Figure 11

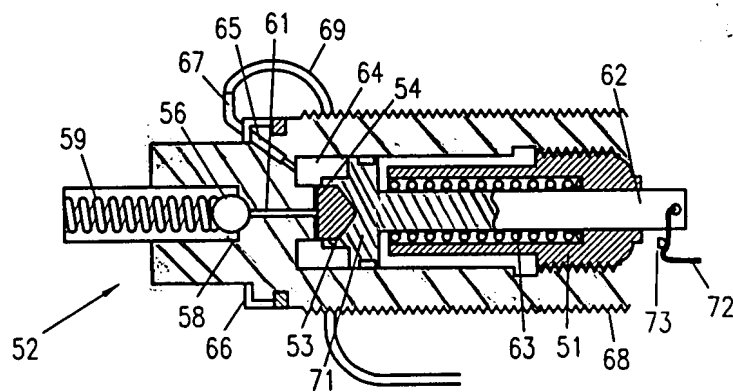
Examiner further argues that the disclosure fails to provide adequate support as to how the hard metal seat prevents a sealing seat from being achieved, and that the valve arm, threaded shank, seat, ball and spring, and associated elements are floating in the valve housing.

Further, regarding inadequate support in the disclosure as to how the hard metal seat prevents a sealing seat from being achieved, the following seeks to remove any ambiguity concerning this issue.

To clarify, considering initially that “a ball 56 engages a hard metal seat 58 . . .” p. 9,

lines 7-8 of the specification, the ball 56, as illustrated in FIG. 11, is shown to be a spherical body and as such, upon engagement with a *hard* surface creates a tangent or a meeting of a curved surface in a single point, thereby preventing “sealable engagement” between the two, or more specifically between the ball 56 and seat 58.

In contrast, a ball engaging a *soft* seat may facilitate sealable engagement. The soft seat would conform in an impinging manner to a substantial portion of the ball’s external circumferential surface, thereby creating sealable engagement between the two.

Regarding the appearance that the valve arm, threaded shank, seat, ball and spring in FIG. 11 are floating in the valve housing, FIG. 11 has been amended so as to properly include hatching which was previously unintentionally omitted, thus effectively providing structural support for such elements within the valve housing and in conjunction with the specification provides further support that (“...one reasonably skilled in the art could make or use the invention from the disclosures in the patent coupled with information known in the art without undue experimentation.”). *In re Buchner*, 929 F.2d 660, 661, 18 USPQ2d 1331, 1332 (Fed. Cir. 1991).
